APPLICATION NO.	FILING DATE	FIRST NAMED INVENTOR	ATTORNEY DOCKET NO.	CONFIRMATION NO.
10/065,715	11/13/2002	Kuo-Chin Huang	OTMP0031USA	4267

Office Action Summary

DETAILED ACTION

FIG.2

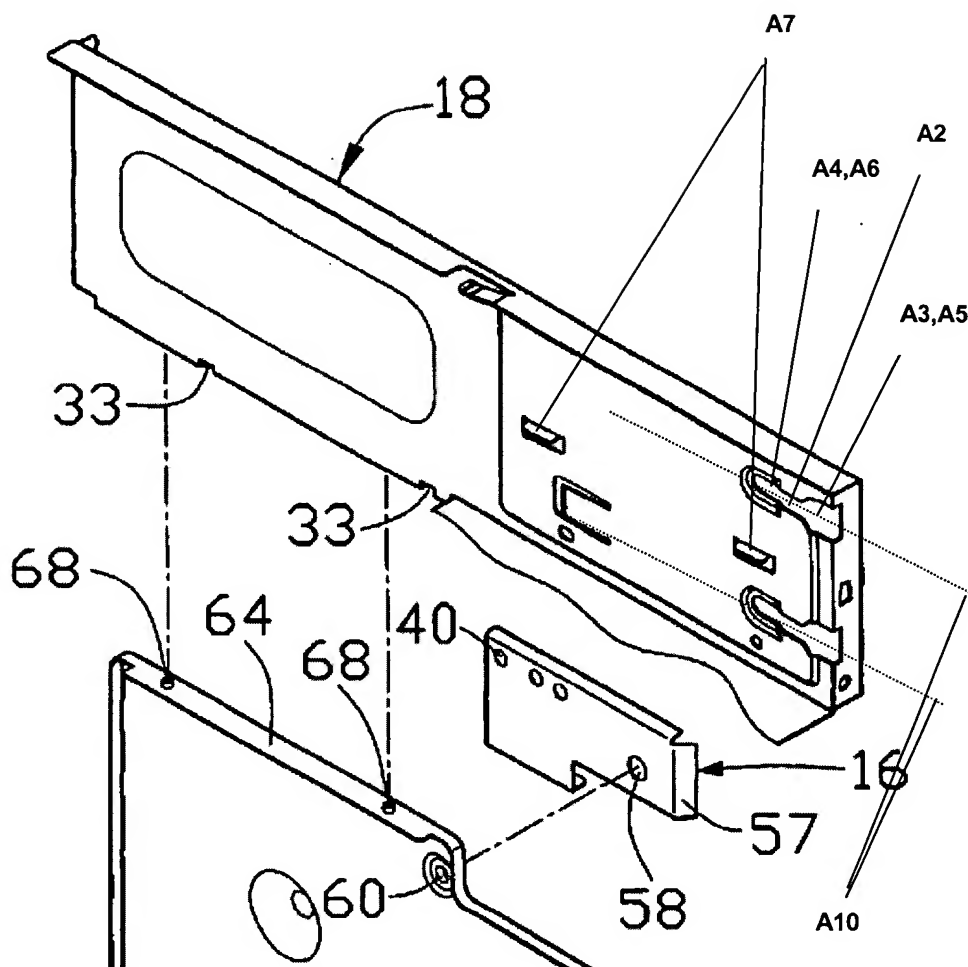
Claims 1, 3 and 5 are rejected under 35 U.S.C. 102(b) as being anticipated by Liao, 6,239,978 (see marked-up attachment).

Regarding claim 1, Liao discloses, in Figure 2, a chute positioning apparatus comprising a positioning board **18**, chutes **A2**, and guide boards **A7**. The chutes **A2** are formed in the positioning board **18**. At least one of the chutes **A2** has a loading-and-unloading section **A3** and a tightening section **A4**. An opening **A5** of the loading-and-unloading section **A3** is greater than an opening **A6** of the tightening section **A4**. The guide boards **A7** are vertically mounted on the positioning board **18** and the guide boards **A7** externally protrude to form a guide surface.

Regarding claim 3, the chutes **A2** are on two contour lines **A10** of a top side **A11** and a bottom side **A12** of the positioning board **18**.

Regarding claim 5, the positioning board **18** is able to form on a main device.
